Re: Technical Revision - Portland Limestone Quarry – File M-1977-344
Bear Creek Drainage – “OUTFALL” Area

Per the Quarry Inspection conducted by Tim Cazier on July 19, 2023 regarding the “outfall” of the Bear Creek Diversion this letter serves as the Technical Revision regarding the regrading and final slope structure of the area of concern. The area of concern shown below:

Figure 1. Map from Inspection Report Showing area of concern

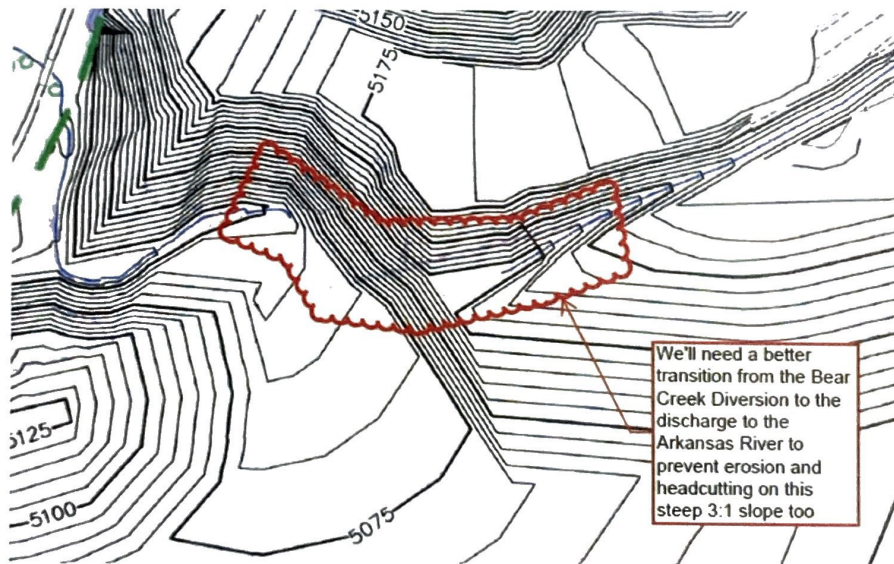
As show in the figure above the slope is too steep on the south side of the Drainage “outfall”. It is Holcim’s proposal and intent that the slope will be regraded and the slope pulled back to a final 3H:1V1 during final reclamation as per Figure 2 and 2a.
